AVISTA CORP. RESPONSE TO REQUEST FOR INFORMATION

CASE NO: 200900-901-894 WITNESS: Elizabeth Andrews

TYPE: Bench Request DEPT: Regulatory Affairs REQUEST NO.: Bench Request No. 1 - TELEPHONE: (509) 495-8601

Illustration No. 1 - 2020 Capital Additions and Pro Formed/Provisional Large/Distinct Projects³

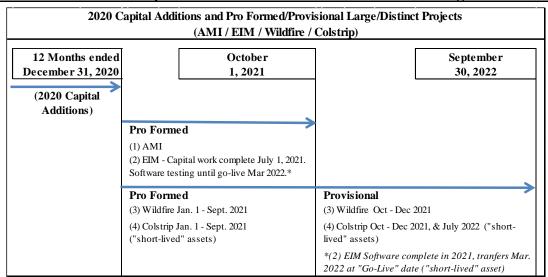
Please note, while this requests specifically asks for provisional portions of adjustments for EIM and Colstrip, the Company had discussed provisional capital additions for Wildfire as well. On rebuttal, at page 15 the Company outlined in the following illustration the pro forma and provisional capital additions.

Also noted at EMA-6T, page 13, lines 8-14 "...included are specific "provisional" large and distinct capital projects planned for completion during the rate effective period, specifically, three months of Wildfire capital additions October 1, 2021 through December 31, 2021⁴, as well as Colstrip Units 3 and 4 investment additions from October 1, 2021 to December 31, 2021, and one project to be complete as of July 2022. The Colstrip investments were included through the rate effective period to reflect short or accelerated depreciable lives."
